PRODUCT / PROCESS CHANGE NOTIFICATION

1.1 Company		STMicroelectronics International N.V
1.2 PCN No.		ADG/20/12130
1.3 Title of PCN		SDIP2F-26L SLLIMM - 2nd series IPM Package Improvement Shenzhen (China) - INDUSTRIAL
1.4 Product Category		IGBT TFS
1.5 Issue date		2020-04-24

SDIP2F-26L SLLIMM™ - 2nd series IPM Package Comparison

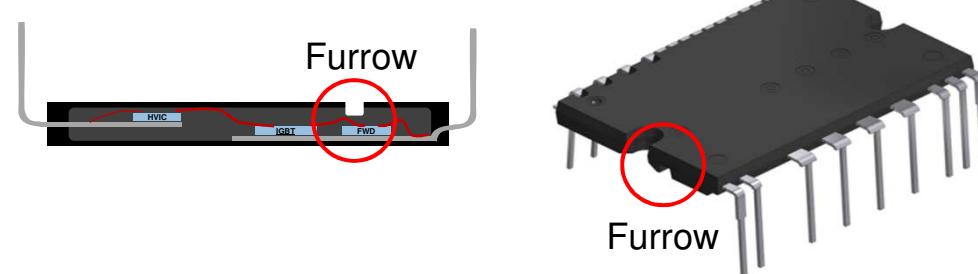
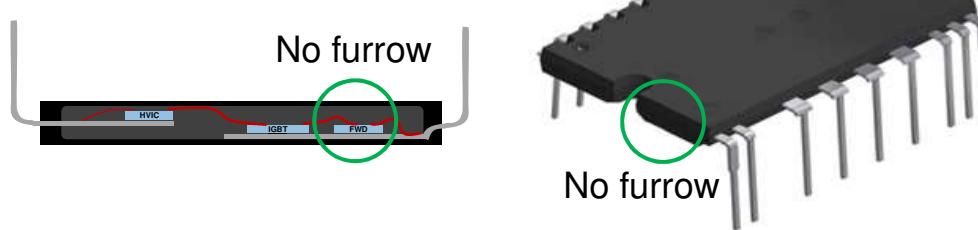
Old	New
4.1 Description	IGBTs housed in SDIP2F-26L SLLIMM - 2nd series IPM are manufactured with molding compound HITACHI GE-401SLM.	IGBTs housed in SDIP2F-26L SLLIMM - 2nd series IPM will be manufactured with a redesigned package and a new molding compound SUMITOMO EME-G591A.
4.2 Anticipated Impact on form,fit, function, quality, reliability or processability?	no impact

Current production

New production

The new molding compound has better characteristics that will advantage in reducing the warpage, allowing UL1557 certification. In addition, the removal of the furrow has made the package more robust, reducing the risk of damage during heat sink screwing process made by the customer.

SDIP2F-26L SLLIMM™ - 2nd series IPM Warpage evaluation

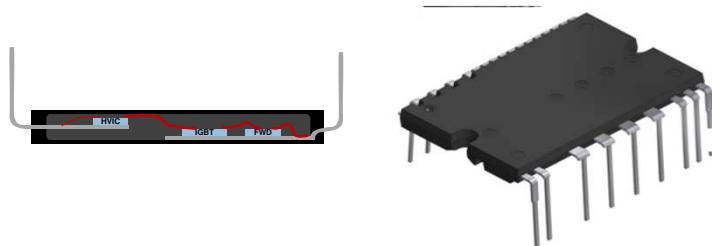
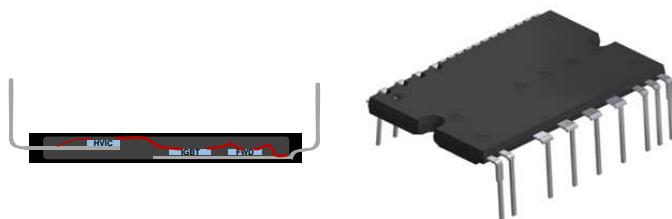
Current production range of warpage Values:
122 to 149um

New production range of warpage Values:
90 to 128um
